# UNITED STATES PATENT AND TRADEMARK OFFICE

APPLICATION NO.	FILING DATE	FIRST NAMED INVENTOR	ATTORNEY DOCKET NO.	CONFIRMATION NO.
10/661,575	09/15/2003	Sung-gi Kim	1572.1109	7969

# Office Action Summary

### **DETAILED ACTION**

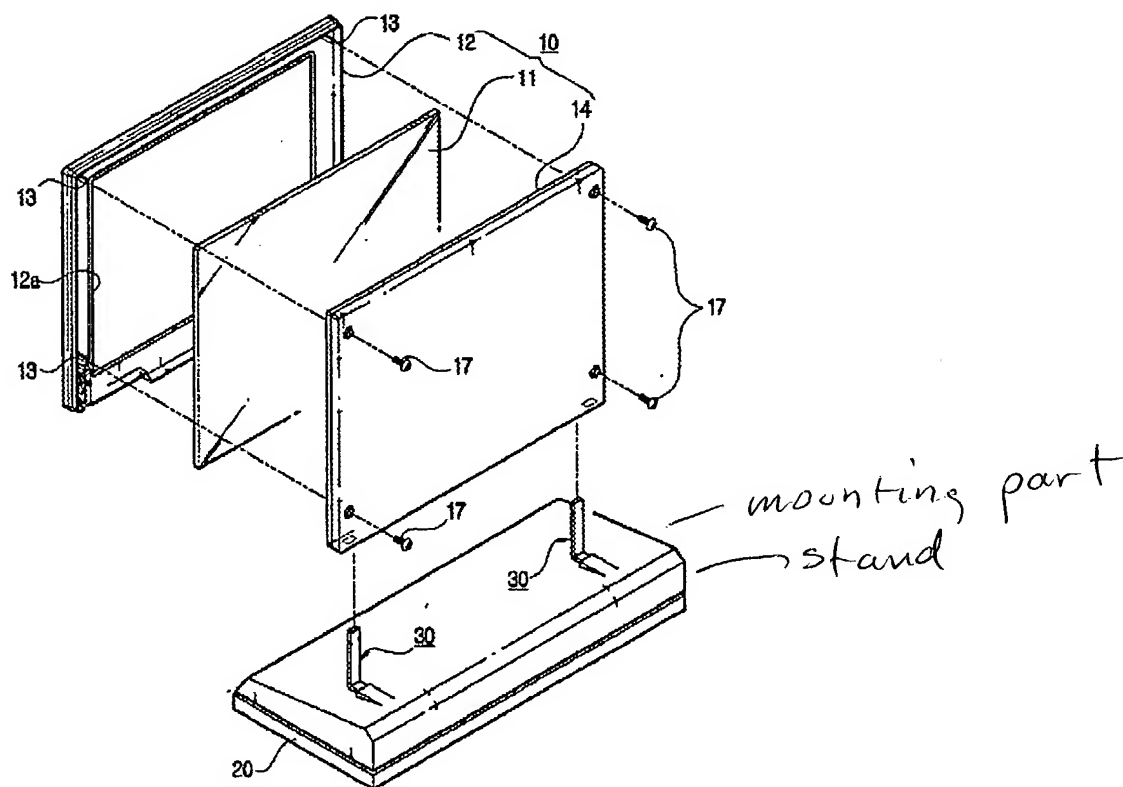
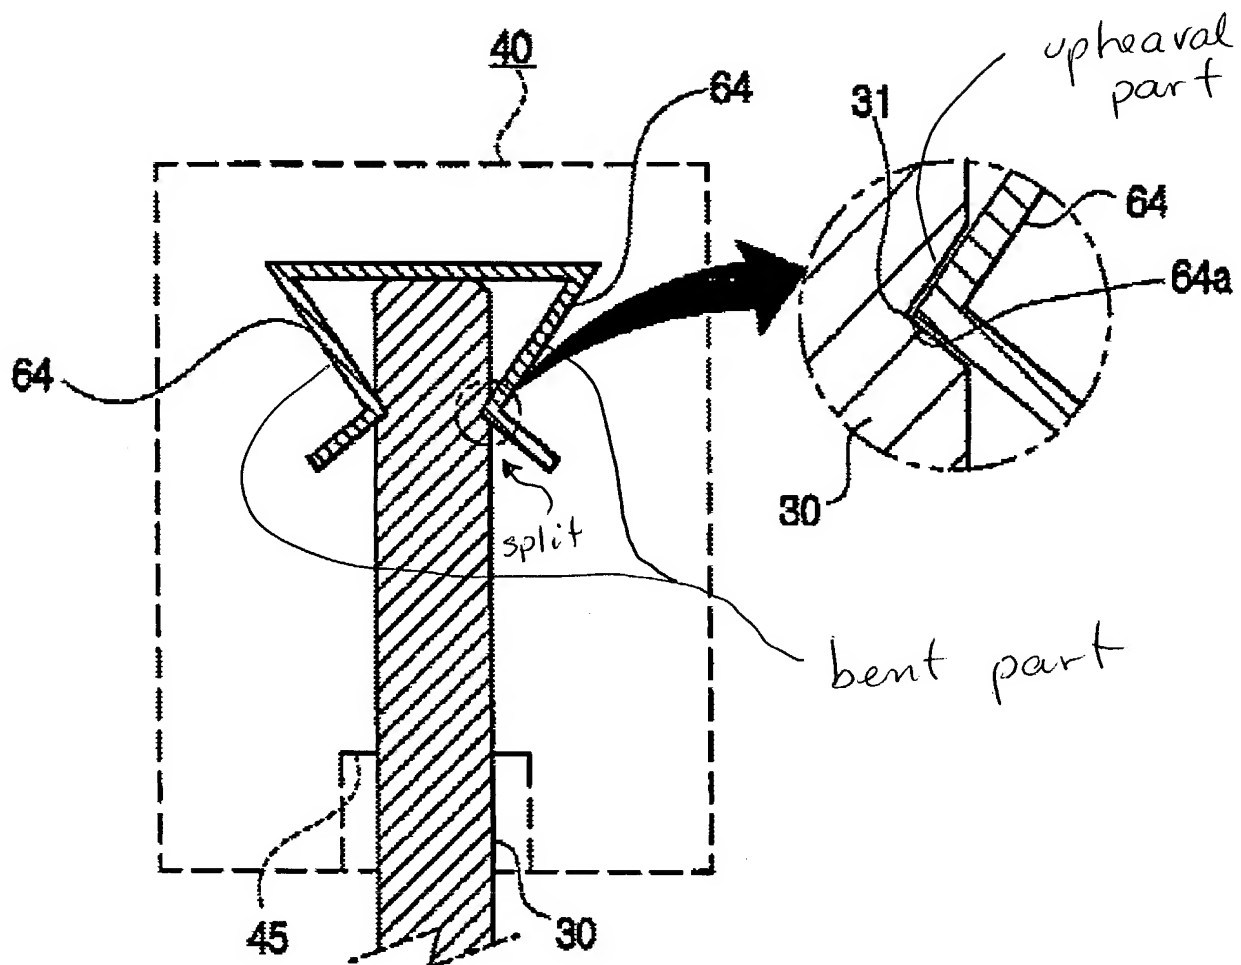
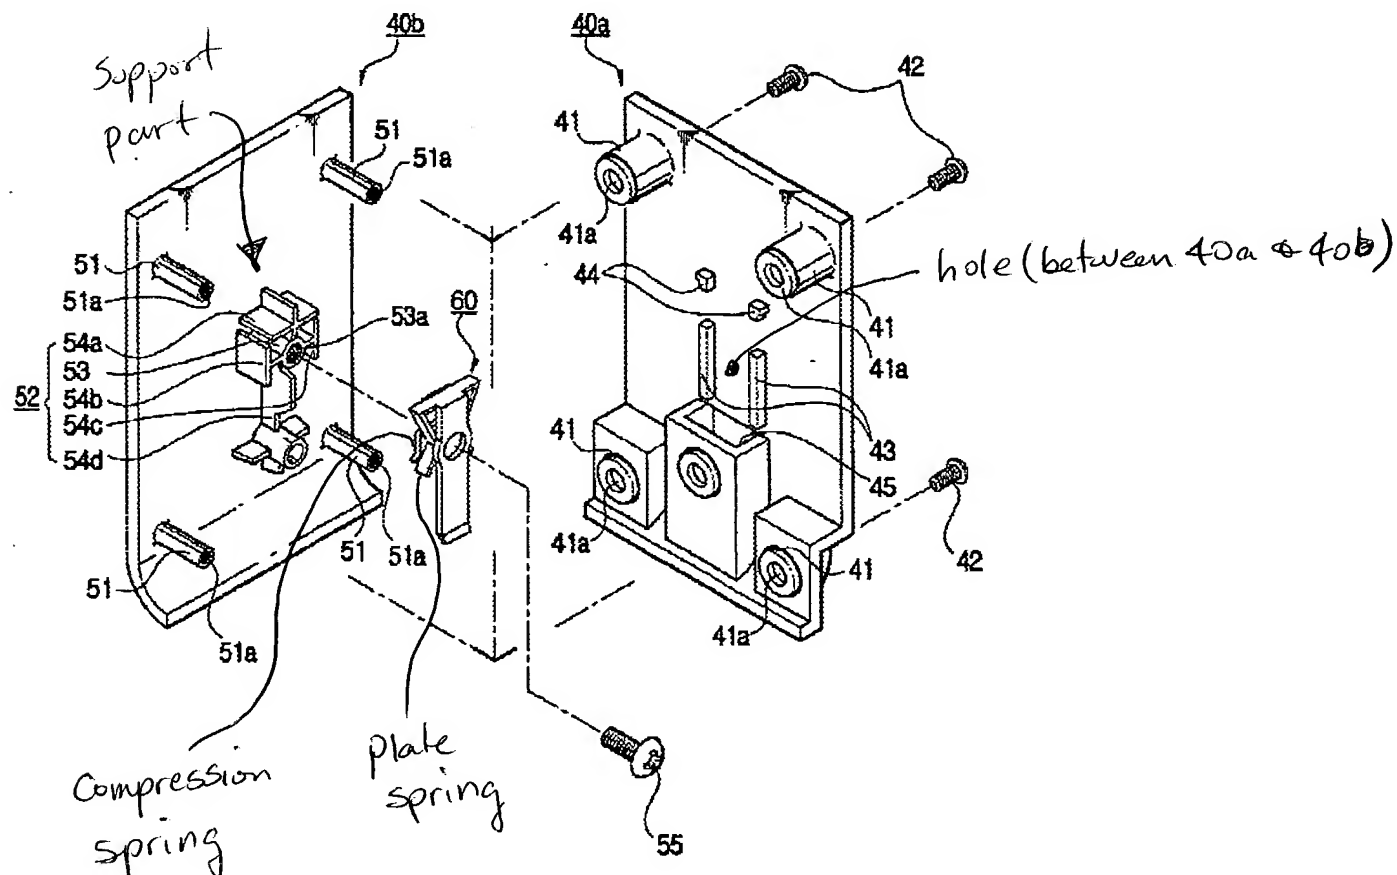
Claims 1-5 and 7-12 are rejected under 35 U.S.C. 102(e) as being anticipated by Byoun et al. (U.S. Patent Pub. No. 2003/0103092). Byoun et al. Teach each feature of the claimed invention as shown in the marked-up figure below.

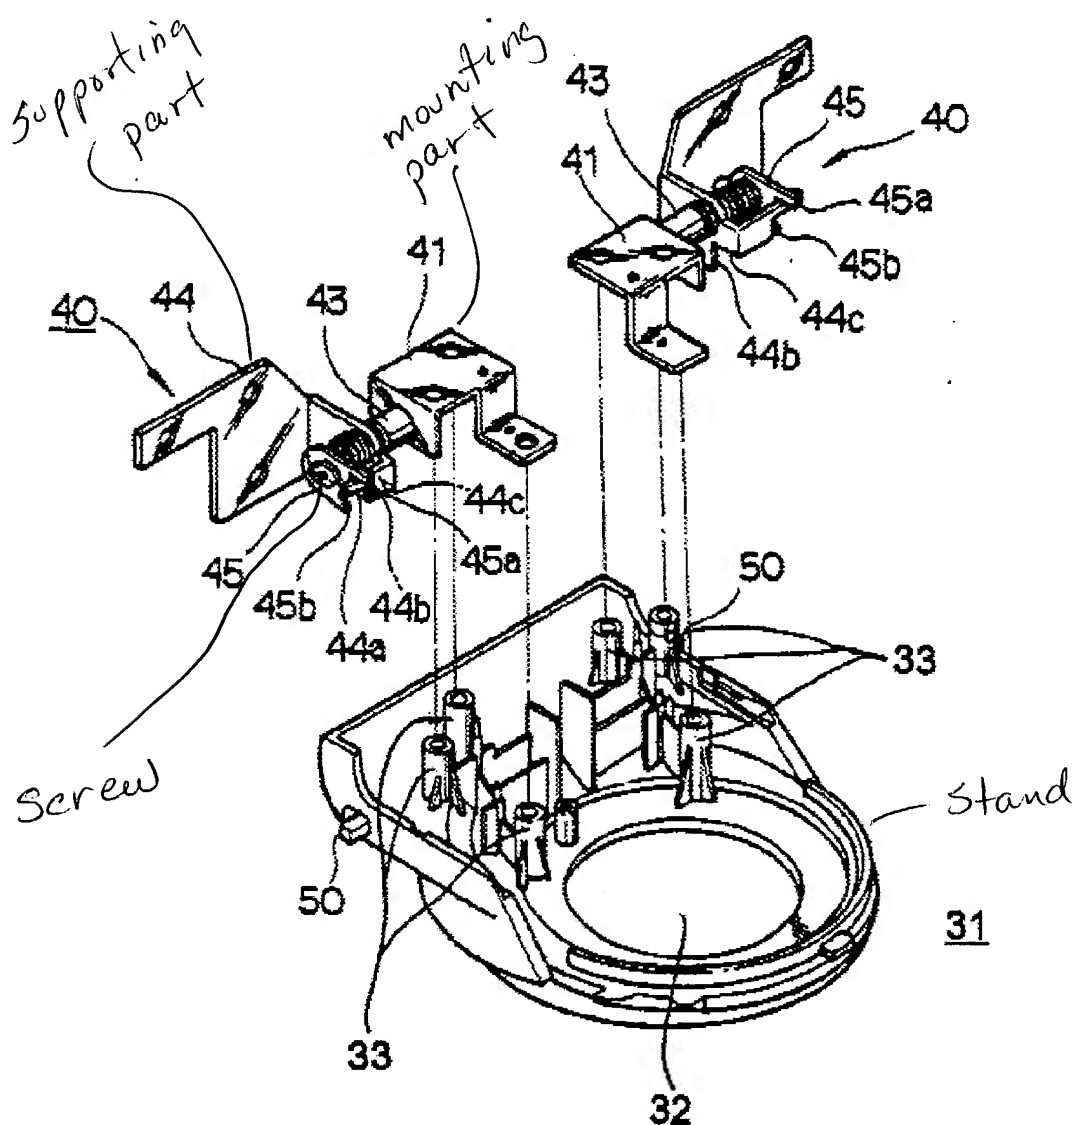
Claims 1 and 2 are rejected under 35 U.S.C. 102(b) as being anticipated by Hong (6,231,021). Hong teaches each feature of the claimed invention as shown below
